## Product Change Notification / MFOL-21ZHLK418

CCB 5033 Initial Notice: Qualification of STAR as an additional final test site for selected MICRF229xx and MICRF230xx device families available in 16L QSOP (3.90mm) package.

**PCN #: MFOL-21ZHLK418**

# Pre and Post Change Summary - Carrier Tape

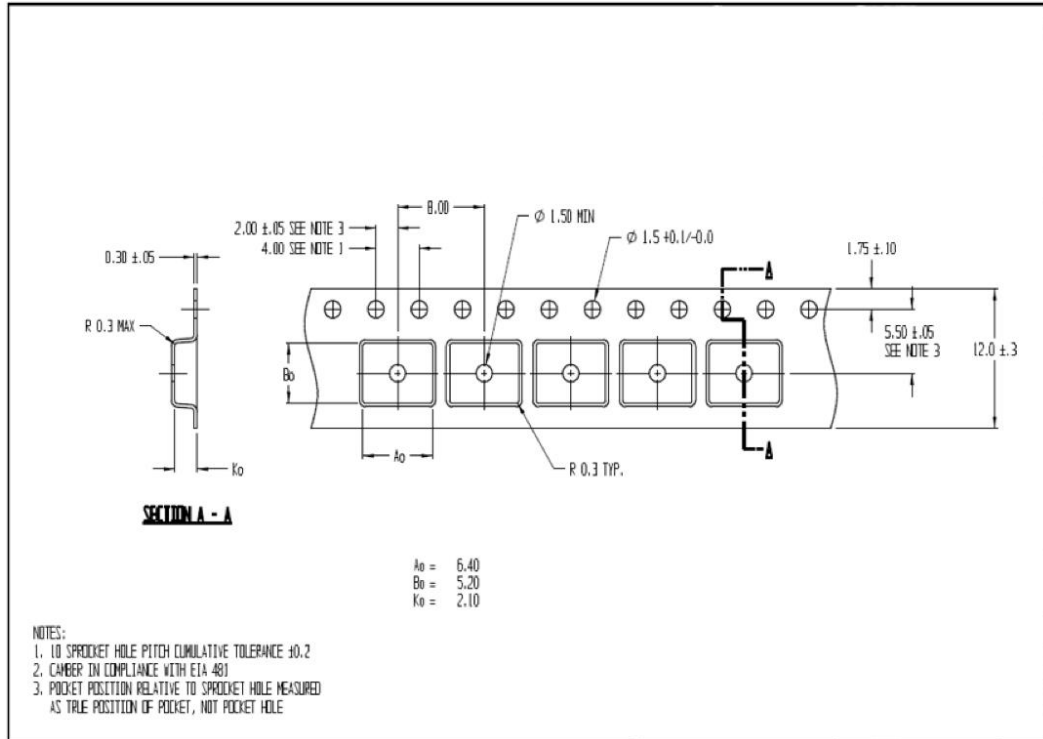
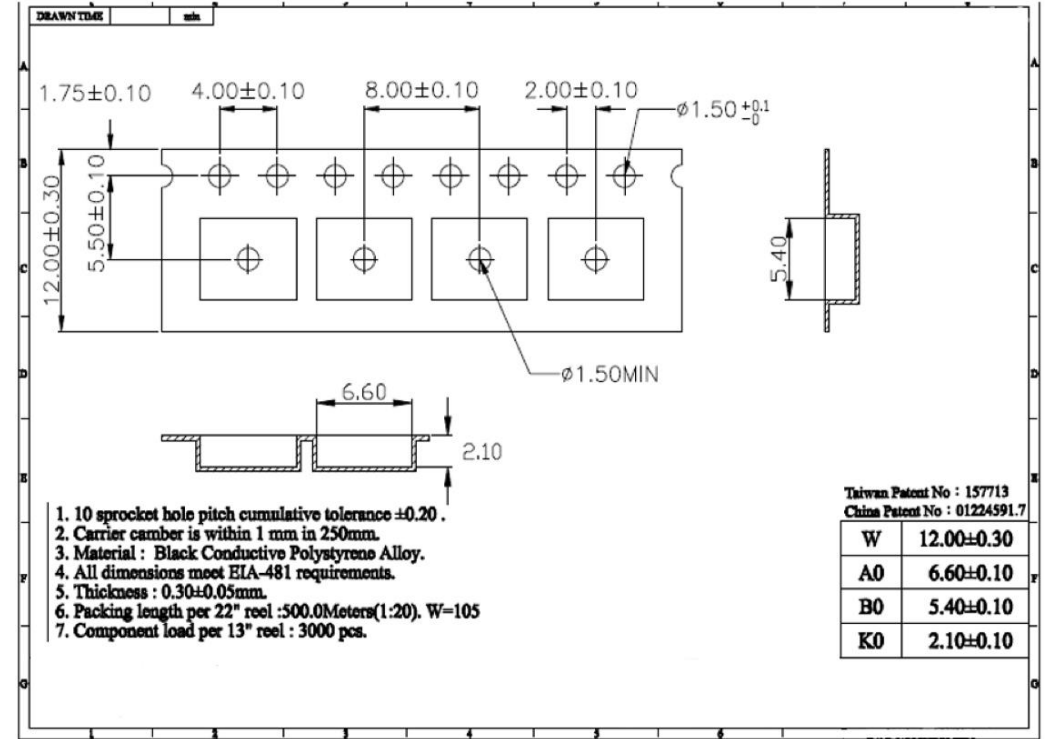
Plant	W (mm.) ±0.3	P (mm.) ±0.1 or Specific	$A_0 \pm 0.1$ or Specific	$B_0 \pm 0.1$ or Specific	$K_0 \pm 0.1$ or Specific
UNIS	12.00	8	6.40	5.20	2.10
STAR	12.00	8	6.60	5.40	2.10

# Pre and Post Change Summary - Cover Tape

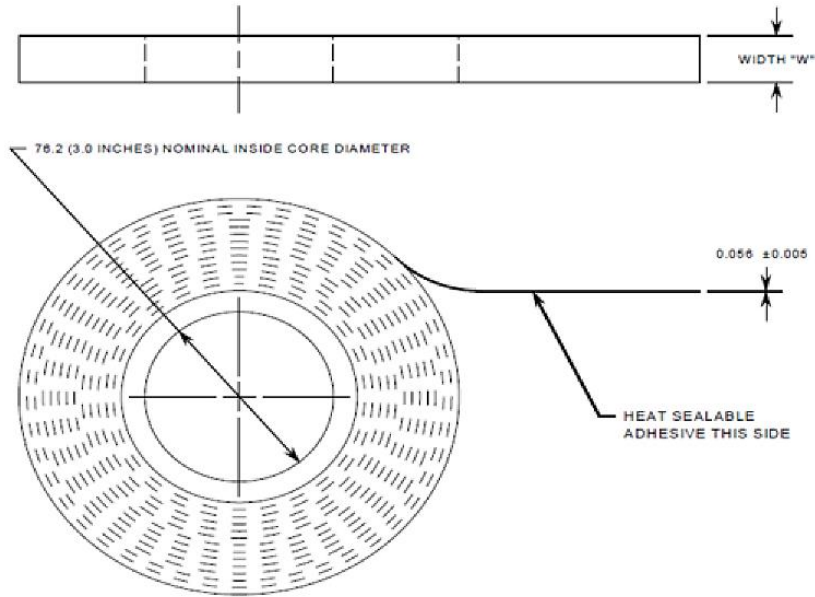
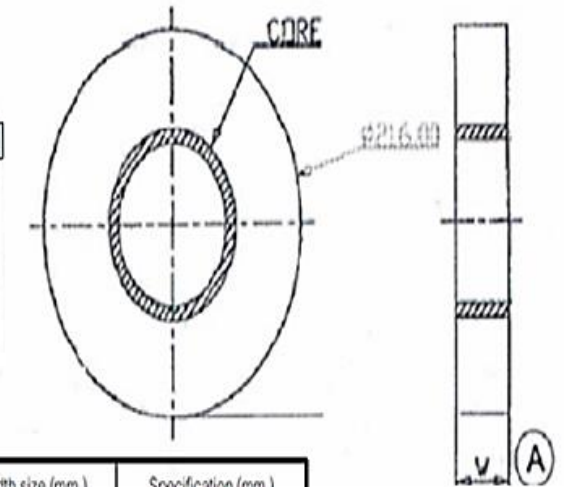
Plant	Carrier Tape Width	Cover Tape Width	Thickness	Color	Sealing mythology
UNIS	12mm	9.20	0.056	Clear	Heat Sealing
STAR	12mm	9.20	0.050	Clear	Heat Sealing

# Pre and Post Change Summary – Plastic Reel

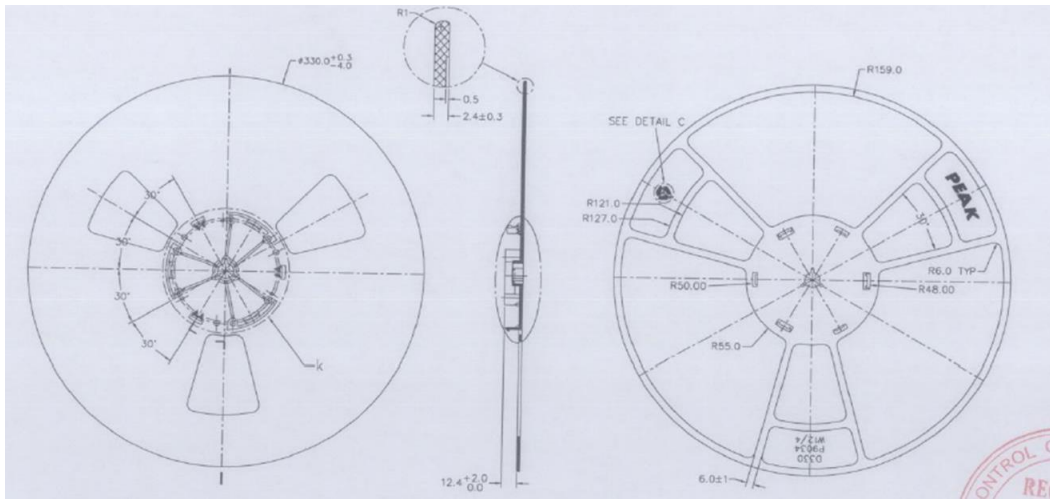
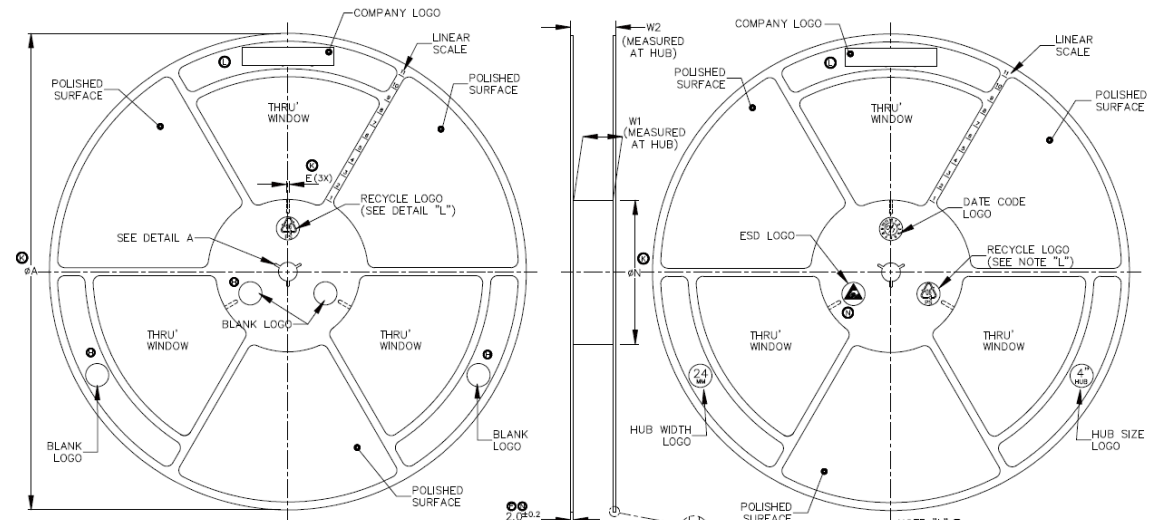
- UNLESS OTHERWISE SPECIFIED
1. MATERIAL: POLYSTYRENE(BLUE)
2. ANTISTATIC COATED
3. FLANGE WARPAGE : 3 MM MAXIMUM
4. ALL DIMENSIONS ARE IN MM
5. ESD – SURFACE RESISTIVITY  
–  $10^8$  TO  $10^{11}$  OHMS/SQ
6. GENERAL TOLERANCE :  $-X.X = \pm 0.4$  ,  $-X.XX = \pm 0.20$
7. TOTAL THICKNESS OF REEL: 18.4 MAX
8. PART NO: P9034

TAPE WIDTH	PRODUCT SPECIFICATIONS				
	Ø PA ±2.0	Ø IN ±2.0	W1	W2 (MAX)	E (MIN)
08MM	330	100	8.4 ± 0.2	14.4	2.5
12MM	330	100	12.4 ± 0.2	18.4	2.5
16MM	330	100	16.4 ± 0.2	22.4	2.5
24MM	330	100	24.4 ± 0.2	30.4	2.5
32MM	330	100	32.4 ± 0.2	38.4	2.5

# Pre and Post Change Summary – Packing Tube dimension

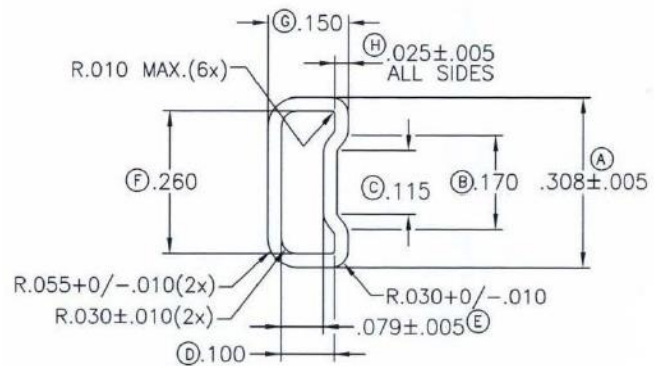
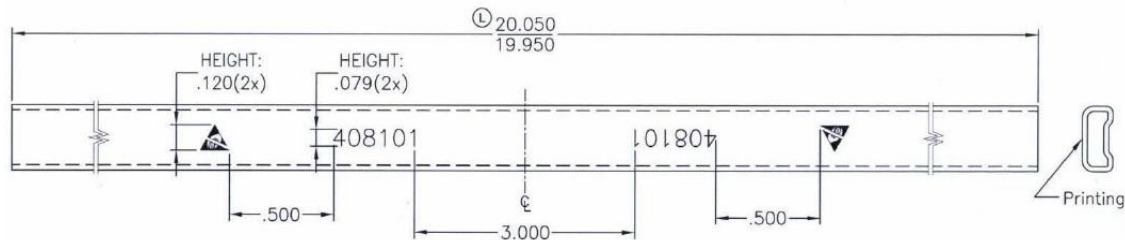
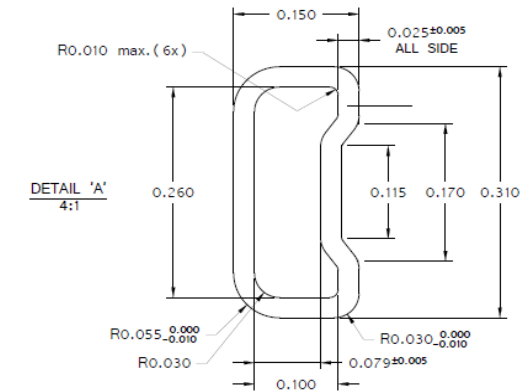
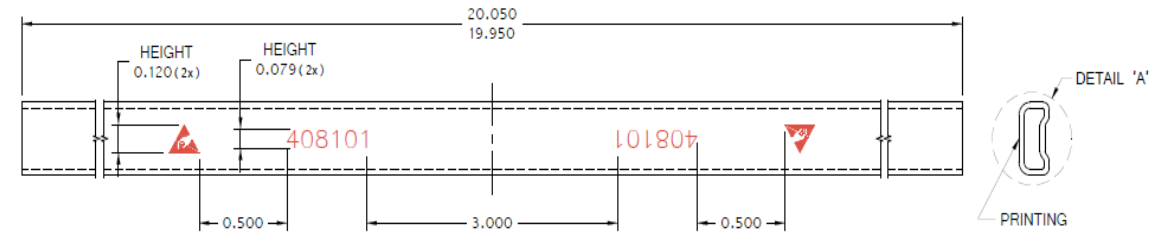
Plant	Tube Color
UNIS	Clear
STAR	Clear
